# UNITED STATES PATENT AND TRADEMARK OFFICE

APPLICATION NO.	FILING DATE	FIRST NAMED INVENTOR	ATTORNEY DOCKET NO.	CONFIRMATION NO.
10/576,560	11/06/2006	Olle Hemmingson	1000500-000385	3806

<b>Office Action Summary</b>	<b>Application No.</b> 10/576,560	<b>Applicant(s)</b> HEMMINGSON, OLLE	
	<b>Examiner</b> BHARAT C. PATEL	<b>Art Unit</b> 3724

## **DETAILED ACTION**

FIG. 5

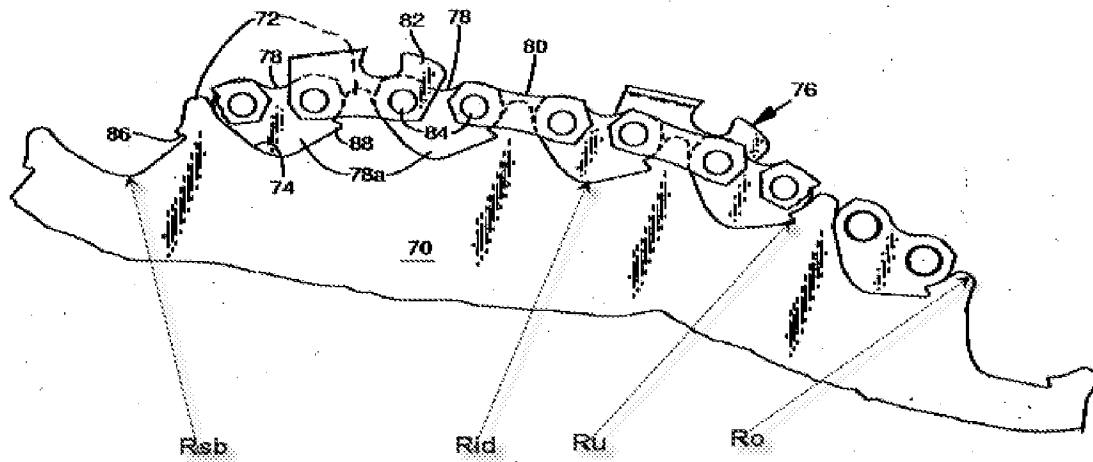
Re claim 2, Carlton teaches that the cam surface 88 on each driving link 78 is designed to press the chain 76 radially outwards against the radial projection 86 by the cam effect, in such a way that, in a tensioned state, the chain is held onto the disk 70 as a result of its shape per Fig. 5 and per col. 4, lines 3-36.

Re claim 4, Carlton teaches that the bottom 74 of the groove has a predetermined number of projections 86 distributed evenly around the circumference of the disk 70 per Fig. 5.

Re claim 5, Carlton teaches that the bottom 74 of the groove has one projection 86 for each driving link 78 per Fig. 5.

Re claim 6, Carlton teaches that radial cross-section of each projection 86 is lug shaped per Fig. 5.

Re claim 7, Carlton teaches that radial cross-section of each projection 86 is pyramid shaped per Fig. 5.

Re claim 8, Carlton teaches that radial cross-section of each projection 86 is dome shaped per Fig. 5.

Re claim 9, Carlton teaches that radial cross-section of each projection 86 is designed as a truncated cone that has a complementary shape to the cam surface 78a of the interacting driving link 78 per Fig. 5.

Re claim 11, Carlton teaches that the construction of the chain 76 is such that the connecting links 80 are spaced radially outwardly with respect to radially outermost portions of the radial projections 86 when the chain is in the neutral position, and when the chain is being driven per Fig. 5.
